PROJECT: Azure ? Torrey Pines North

CITY OF LAS VEGAS INTER-OFFICE MEMORANDUM		DATE: May 11, 2016
TO: Land Development Services Department of Building & Safety		FROM: Albert Sung, P.E. Flood Control Project Engineer Department of Public Works
SUBJECT:	Drainage Study for: Azure & Torrey Pines North	COPIES TO: Triton Engineering
Cross Streets:	SWC of Azure Drive & Torrey Pines Drive	DR Horton
File Number:	F:\Depot\DSMemos\DS4782C.doc	Bart Anderson, P.E., DevCo
Parcel Number:	125-26-203-002; -003 & -004	
Zoning Action:	ZON-62784; WVR-62786 & TMP-62787	
FEMA Flood Zone	YES NO X	
Proposed Storm Drain	YES NO X

Addendum #2
TO THE
TECHNICAL DRAINAGE STUDY
FOR
Azure & Torrey Pines North
Residential Development

**Subject: Addendum #2 to the Technical Drainage Study for
Azure & Torrey Pines North Residential Development
DS4782A**

PLANNING APPROVAL

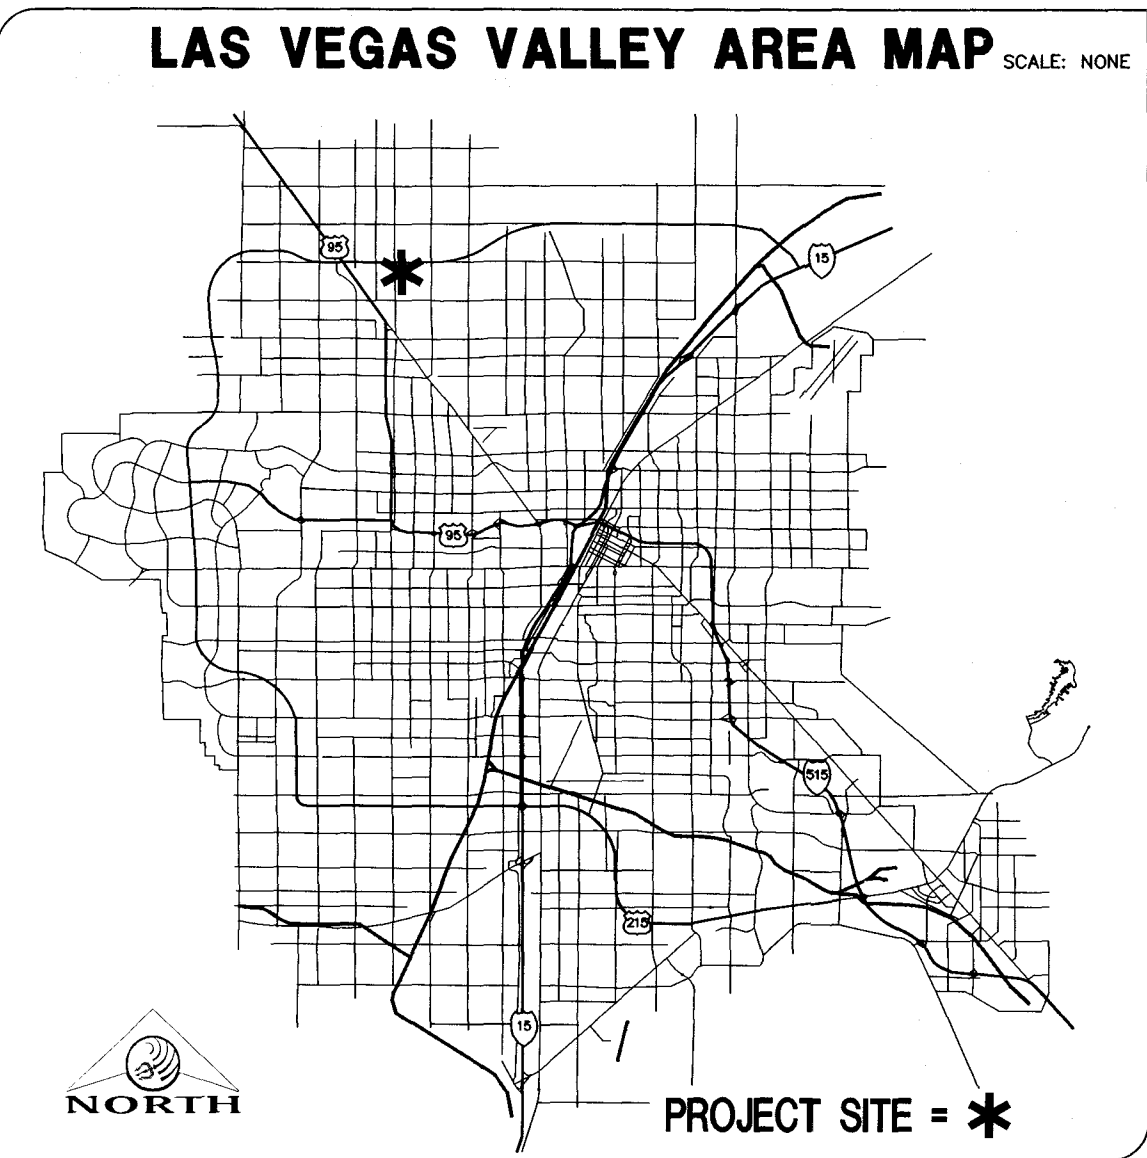
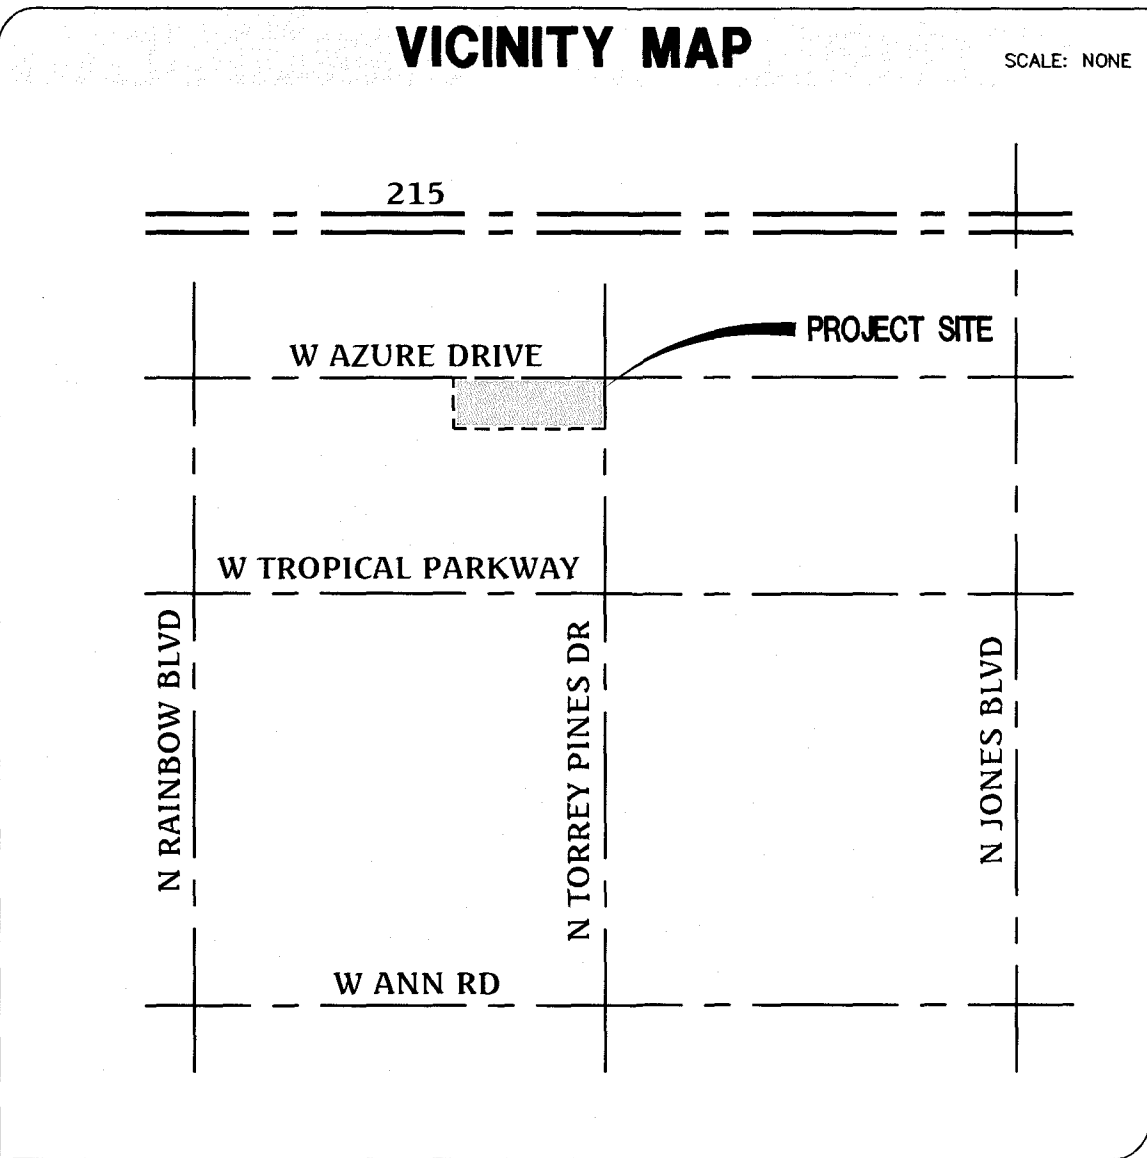
- 1. Second Request: Sites with a grade difference of 2 feet above or below existing area required to have approval from the City Planning and Development Department. The engineer must submit copies of the grading plans and detail sheet with a letter justifying the grade difference to the City Planning Department (702.229-6301). The engineer must provide Planning approval with the next submittal.**

The coordination with the Planning and Development Department was done as requested. A copy of the approval document is included in this submittal.

Our project is a 6.08 acre infill development which is bounded by existing development on one side. The elevation of our project is set by the drainage outlet at the east end of our site. As you can see from the drainage plans that accompanied our letter we have a slope of 0.5% from the drainage outlet street intersection to the top of the cul-de-sac bulb at the west end of the project. This is the minimum slope that we could get agreement on with in CLV Flood Control.

We must match the elevation of the existing ground at the outlet point for our drainage. Under these conditions the pad grades shown on the plans are the lowest practical elevations possible. The pads on the existing development to the south of our site were built at grade at the time which makes the difference in pads across the boundary wall about 2 to 3' feet. For our site to drain properly, the pads will need to be about three feet higher in the worst case than existing ground along the east boundary of our site. We have virtually no flexibility with the constraints we have on the project. It should be noted that we clearly showed the worst case condition on the sections that were part of the Tentative Map (TMP-62787) that was approved on 4/6/16.

DR HORTON
AZURE / TORREY PINES NORTH
AZURE DRIVE
PLAN AND PROFILE
8+50 - 15+00

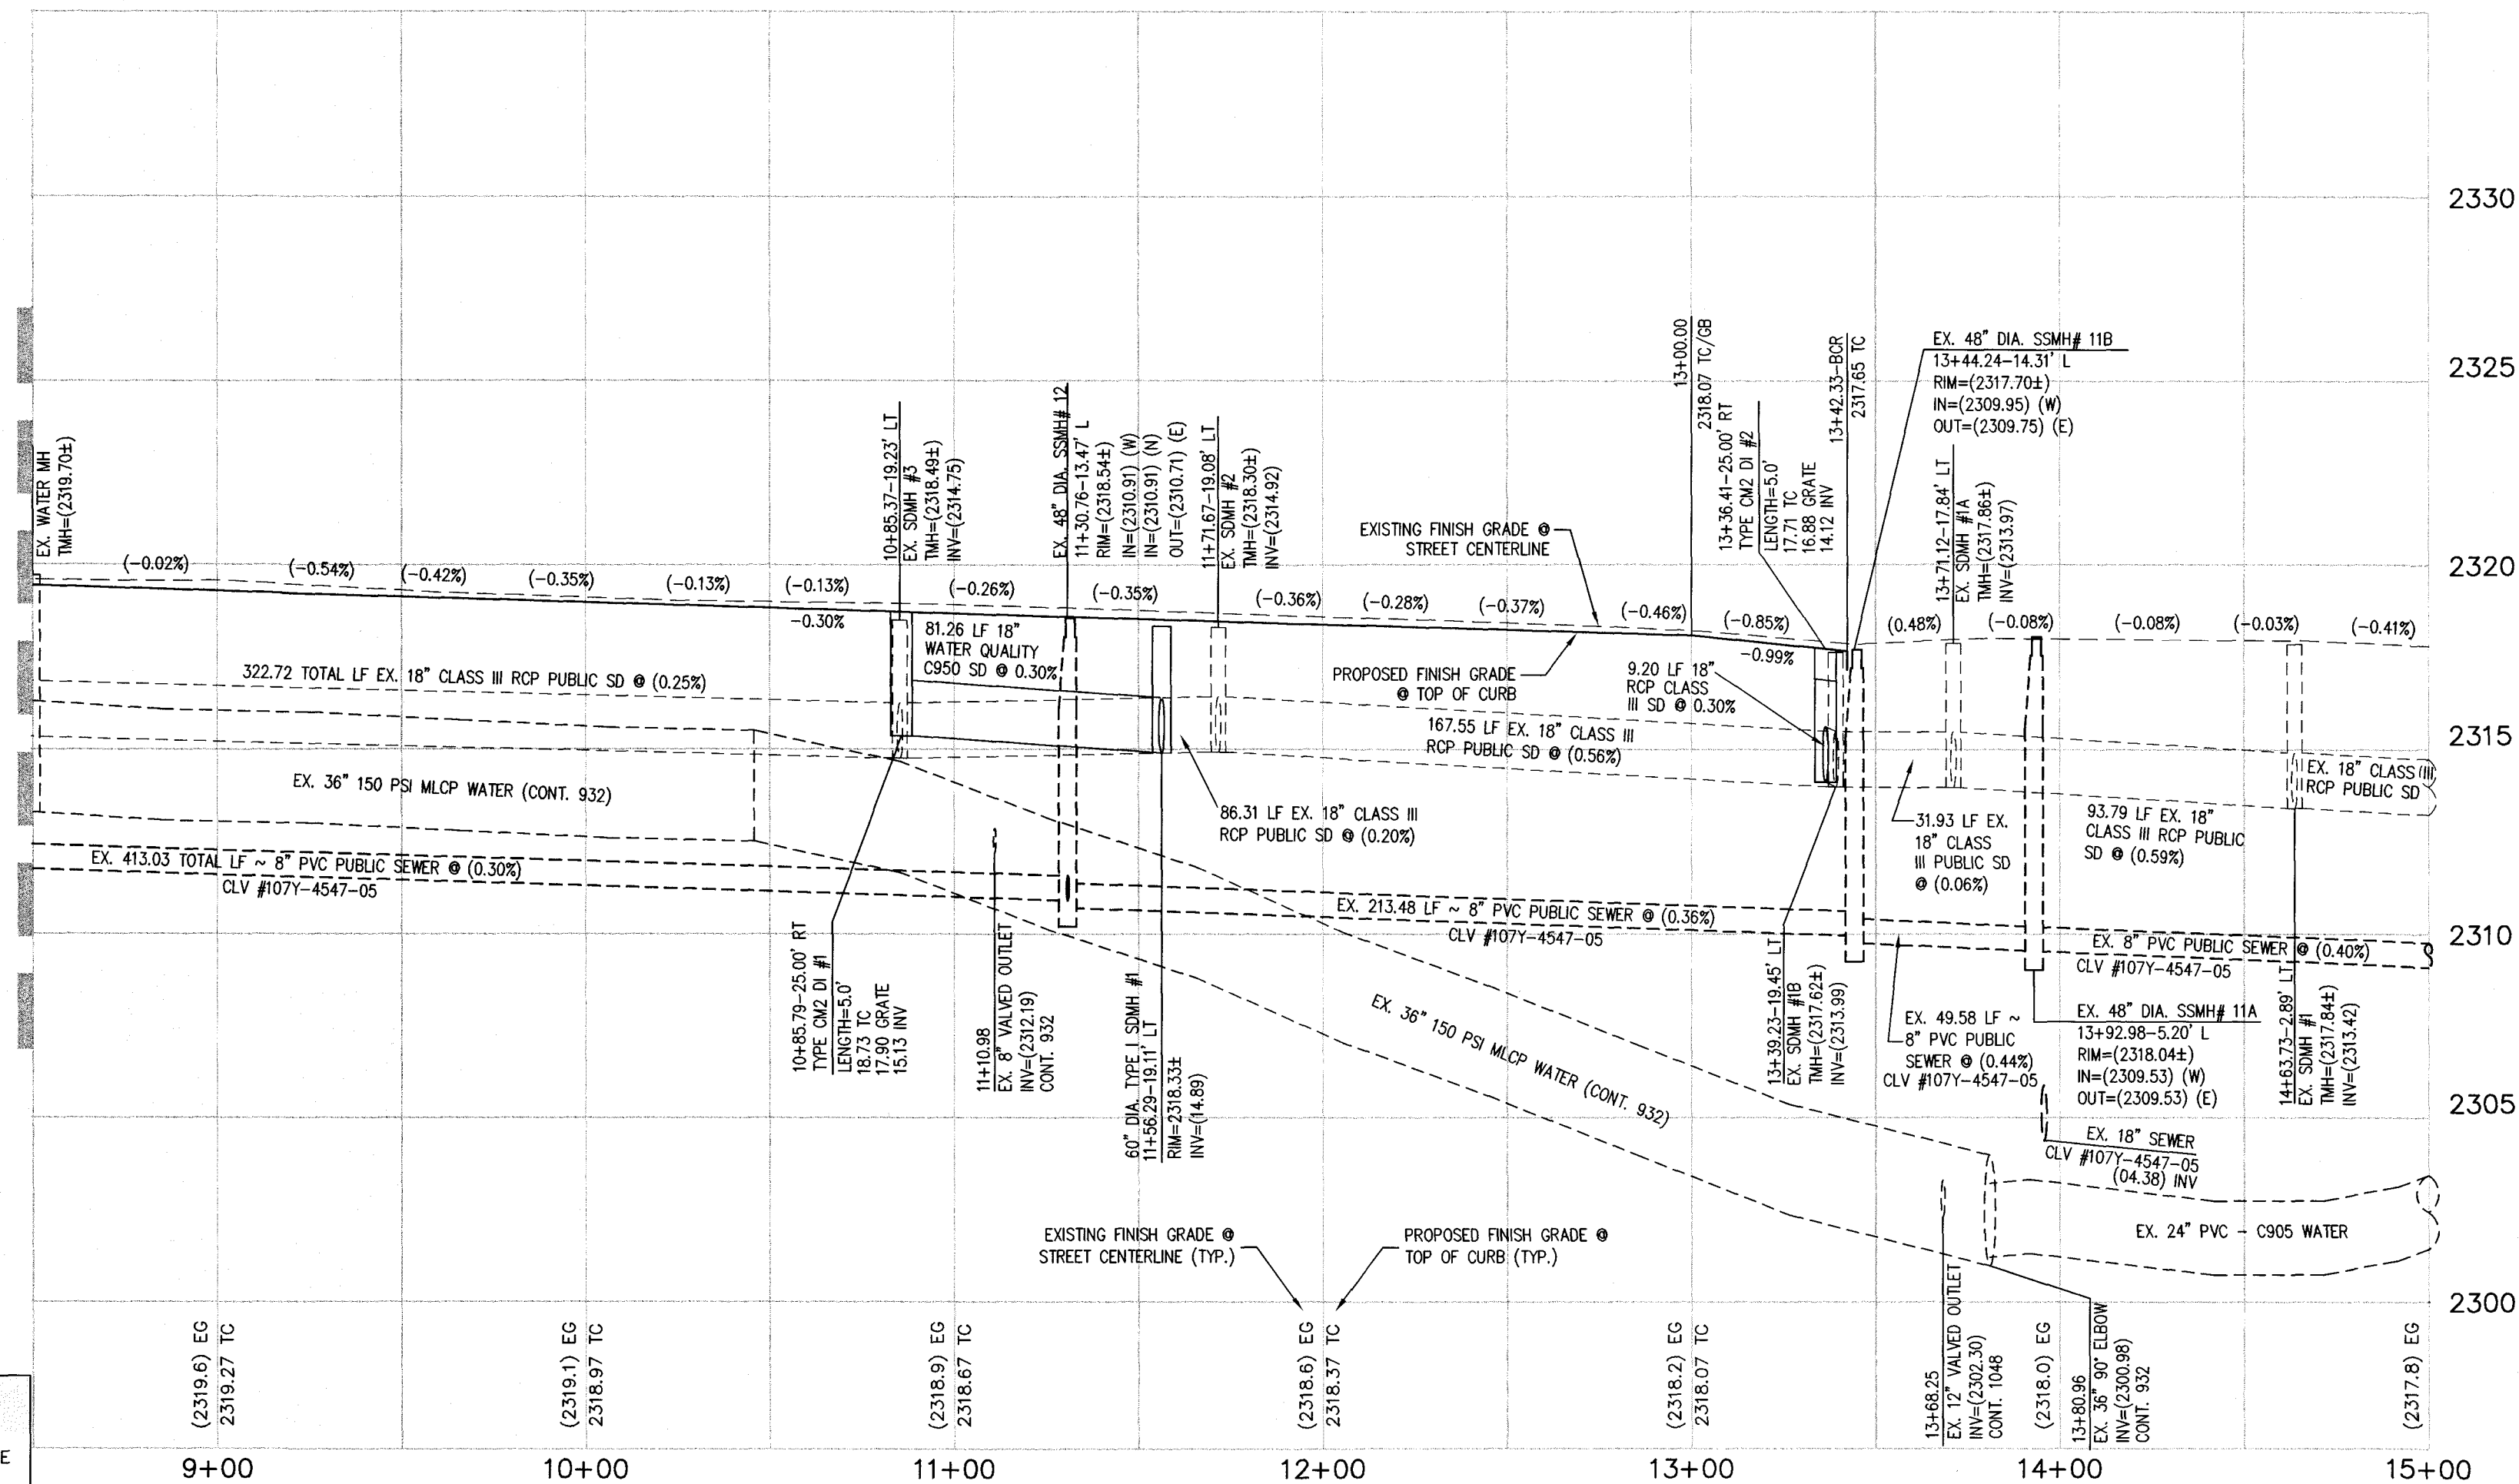
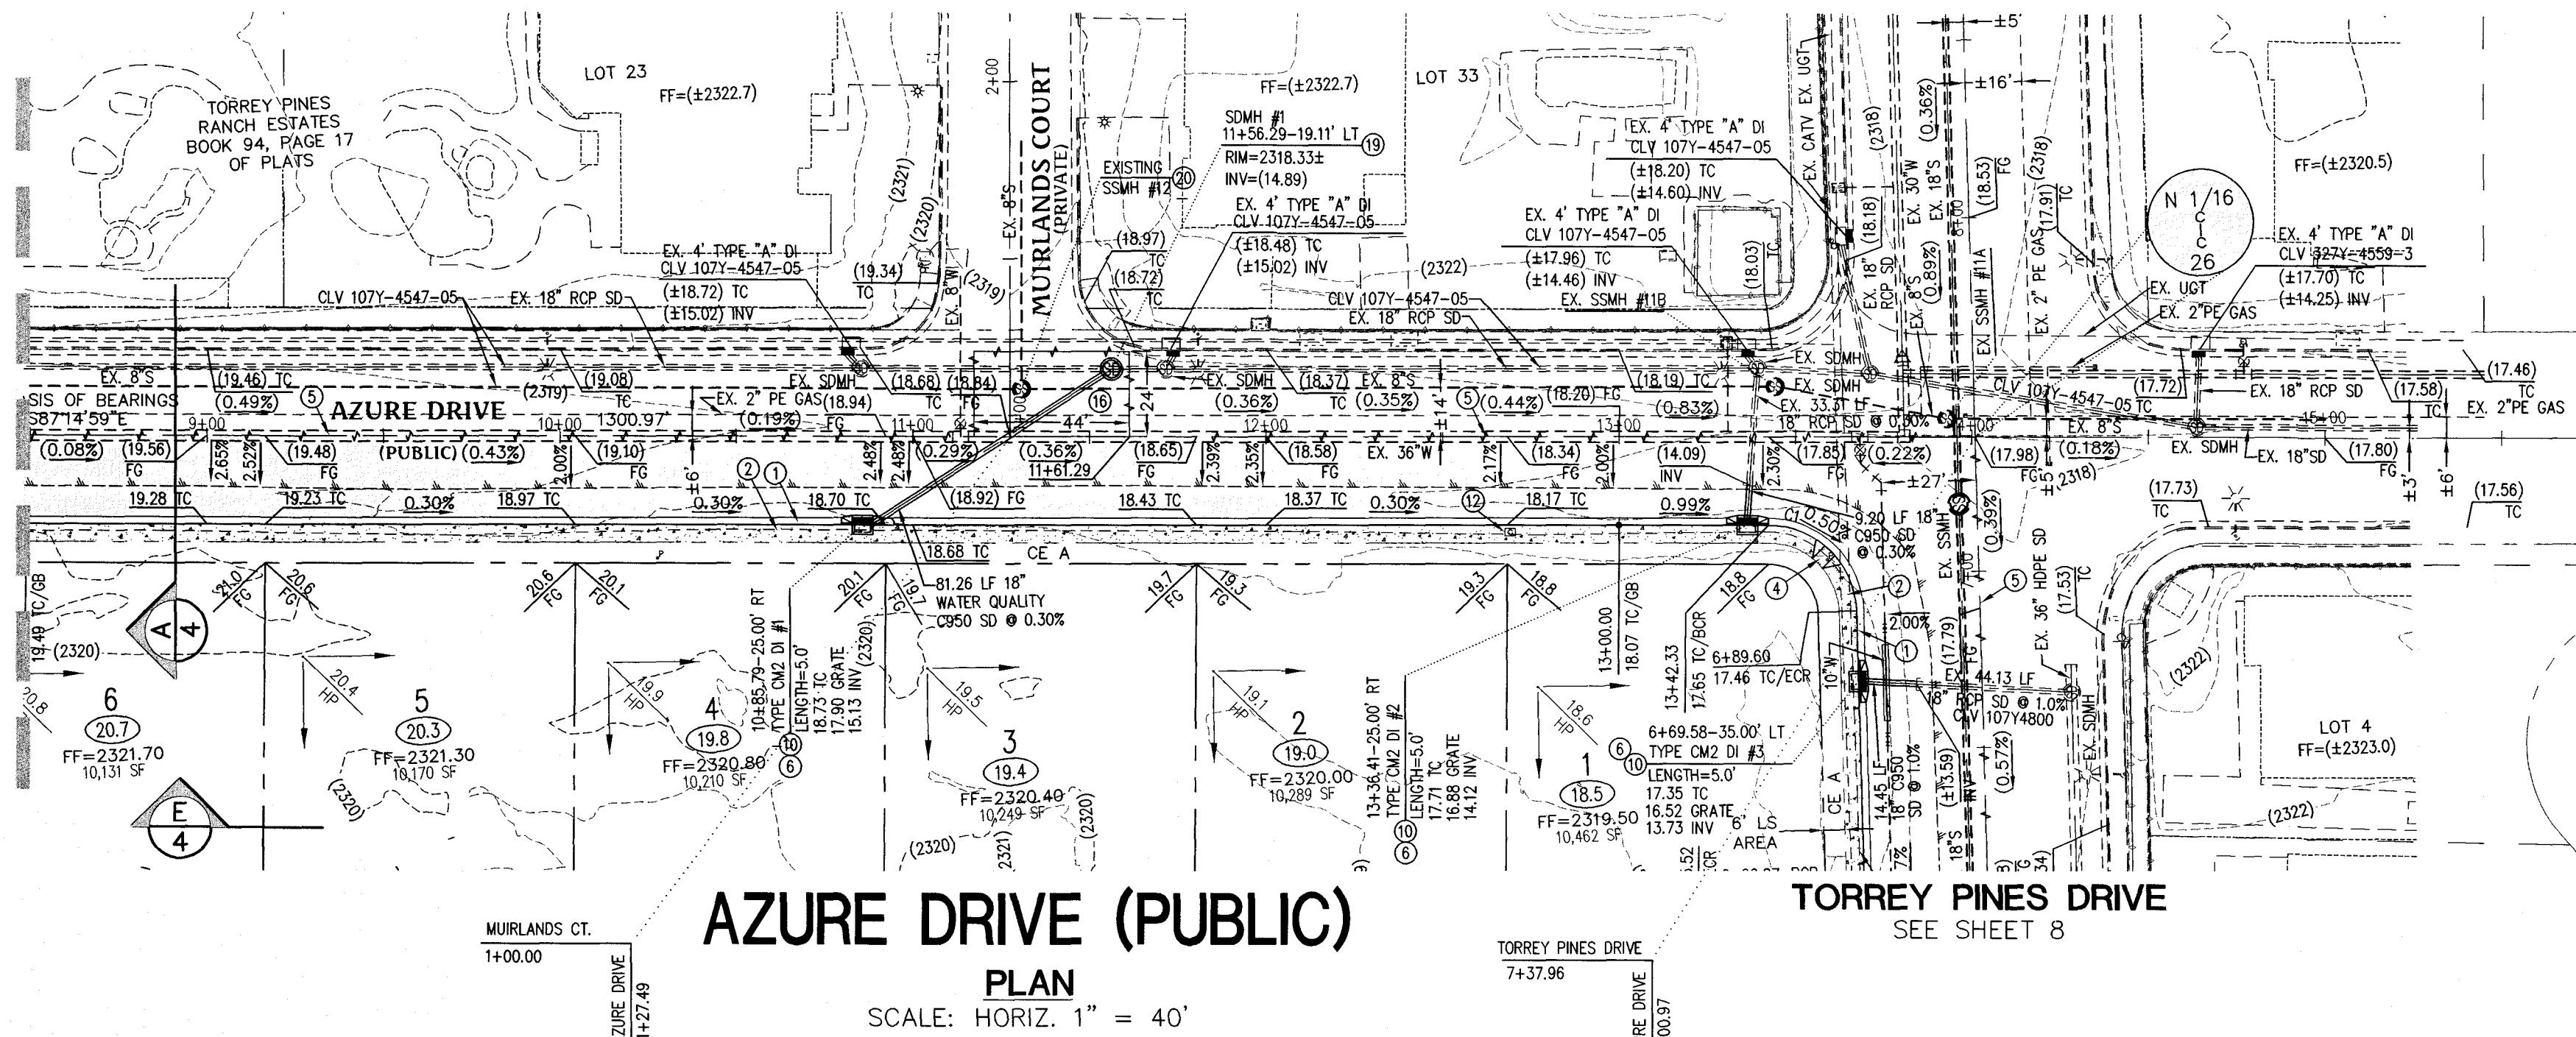
- Second Request:** Sites with a grade difference of 2 feet above or below existing are required to have approval from the City Planning and Development Department. The engineer must submit copies of the grading plans and detail sheet with a letter justifying the grade difference to the City Planning Department (229-6301). The engineer must provide Planning approval with the next submittal.
- Second Request:** Provide a nominal drop inlet at approximately Station 7+50 in Azure Drive. Note that nominal drop inlets must be provided at an interval of maximum 600' to collect nuisance flows. Revise the grading plan and all pertinent plans and construction note accordingly.

The response was to provide the drop inlet at Station 11+50 instead of Station 7+50 because of utility conflict. It is however, the two proposed drop inlets at Station 11+50 and Station 13+42.33 are not at an optimum and efficient spacing. Relocate the one at Station 11+50 to the far west end at approximately Station 4+50.

The response was to provide the drop inlet at Station 11+50 instead of Station 7+50 because of utility conflict. It is, however, the two proposed drop inlets at Station 11+50 and Station 13+42.33 are not at an optimum and efficient spacing. Relocate the one at Station 11+50 to the far west end at approximately 4+50.

This issue was discussed with yourself Albert Sung and Peter Jackson of City of Las Vegas staff on May 1, 2016. The utility conflict is a large water transmission pipeline, which is located in Azure Drive along the entire length of the project, and is in conflict with drop inlets placed anywhere suggested. The depth of the existing pipeline does increase as it continues toward Torrey Pines Drive. It was agreed to place a nominal inlet, on an angled lateral pipe, as close as possible to the existing pipeline, but extending as far west from the inlet at 11+50 as possible. Revisions are shown on the drawings in this submittal.
